FORT ST. VRAIN NUCLEAR GENERATING STATION

AMENDMENT TO FACILITY OPERATING LICENSE

Amendment No. 28
License No. DPR-34

ATTACHMENT TO LICENSE AMENDMENT

Figure 4.1.7-1. Allowable Difference (Mismatch) Between Region Outlet Temperature and Core Average Outlet Temperature

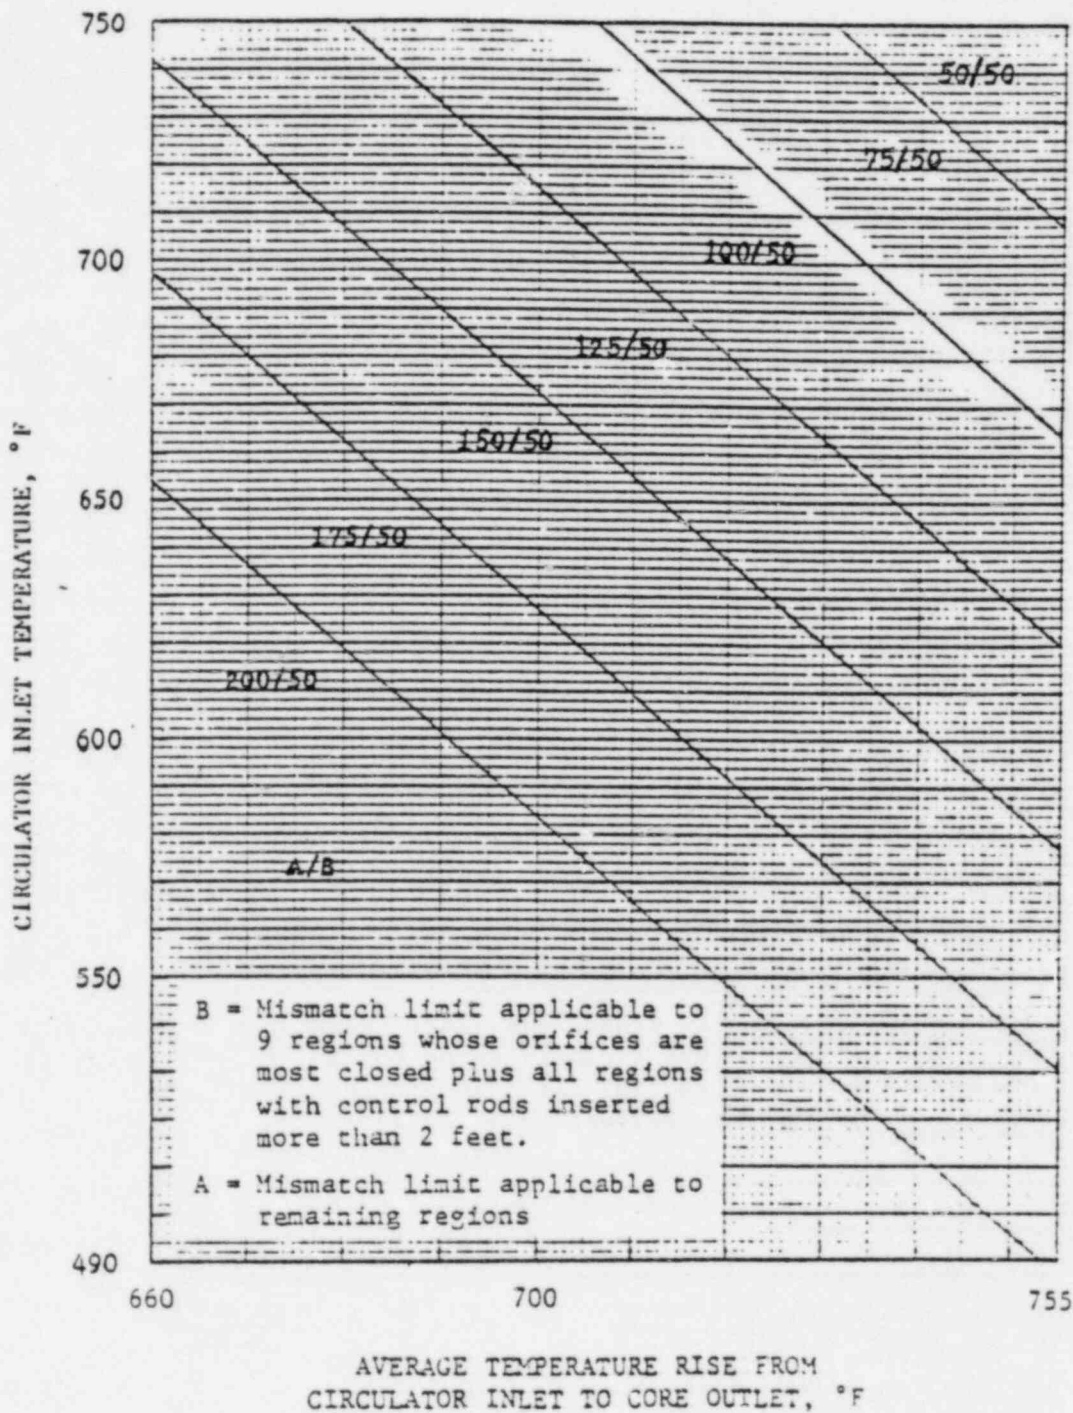
- a) For a core average outlet temperature greater than or equal to 950°F, the core inlet orifice valves shall be adjusted to the following conditions: the individual region outlet temperature for the nine regions whose valves are most fully closed, and any region with control rods inserted more than two feet into the core, shall not exceed the core average outlet temperature by more than the limit (Mismatch B) shown in Figure 4.1.7-1. The individual region outlet temperature for the remaining regions shall not exceed the core average outlet temperature by more than the limit (Mismatch A) shown in Figure 4.1.7-1.

During RT-500K testing, the difference (i.e., mismatch) between the measured region outlet temperature of any region and the core average outlet temperature at 100% power was maintained within the limits of Figure 4.1.7-1. The limits in this figure are more conservative than those used to develop Specification SL 3.1 and those contained in Specification LCO 4.1.7 at the time RT-500K was conducted. In addition, Figure 4.1.7-1 directly limits the maximum region outlet temperature to 1,555°F, which is consistent with Table 3.6-1 of the FSAR. By requiring that the limits in Figure 4.1.7-1 be met, maximum
